IMAGE VELOCITY SENSOR SUBSYSTEM

AD HOC REVIEW GROUP

FINAL REPORT

SEPTEMBER 1968

Figure 1. IVS Power Spectral Density and Brightness
Operating Regime.

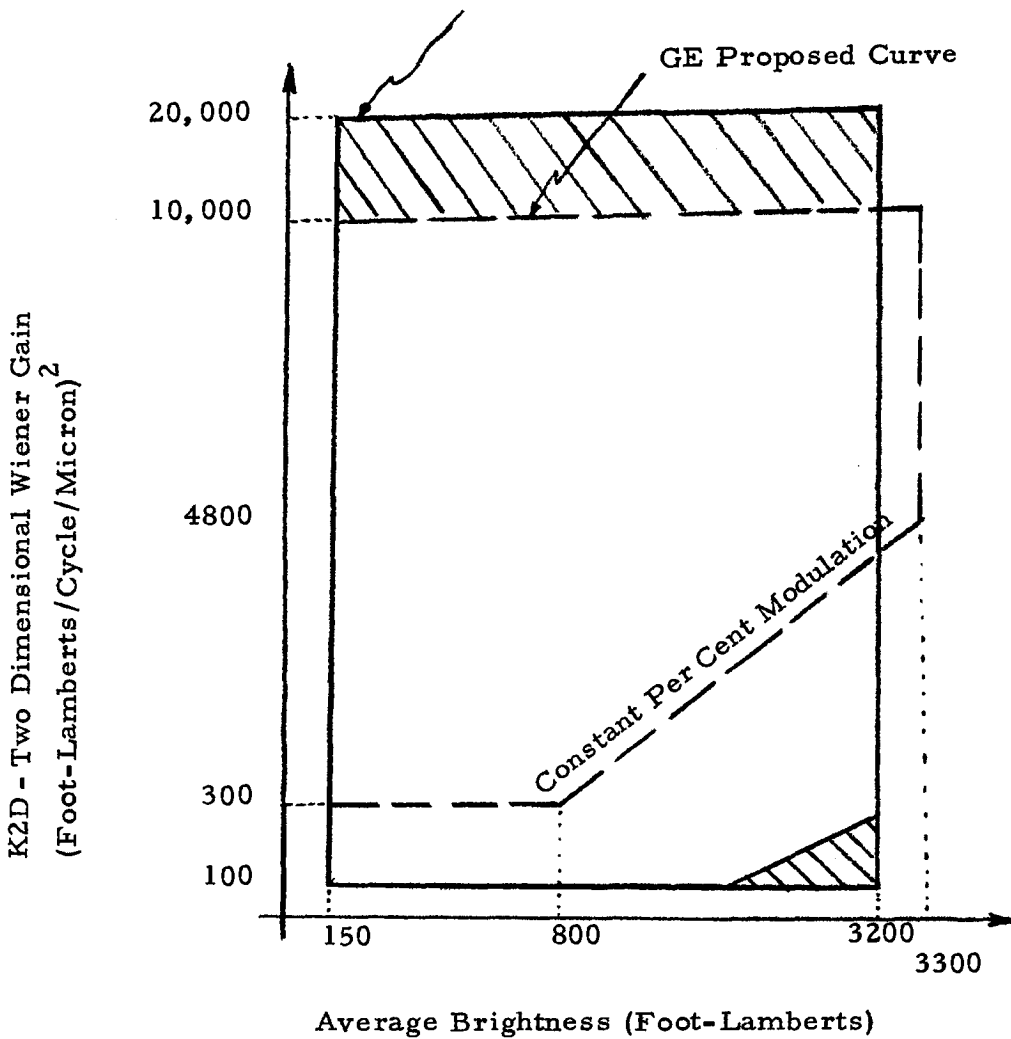
No formal specification has yet been made. The revised Wiener spectrum indicated as forming the current requirement was a matter of disagreement between Aerospace and GE. It appears that, assuming the more favorable IVS illumination as a result of using all the diverted light below 15° sun angle, the anticipated specification is reasonable with a questionable area remaining in the region of high illumination and low modulation. There is a question about the specification of Wiener spectrum at 100 feet per cycle. For purposes of vendor selection and proof of feasibility of devices, it appears desirable to agree to a Wiener spectrum box outline (see Figure 1) quickly and refine it as necessary later.

c. It is recommended that both the Goodyear and the Hycon devices be continued even though they both probably will not meet the low modulation-high illuminance corner (Wiener spectrum diagram - Figure 1) of the present tentative specification.

a. Determine the Wiener spectrum illumination region to be specified as soon as possible, but continue to study the implications of the specification intensively.
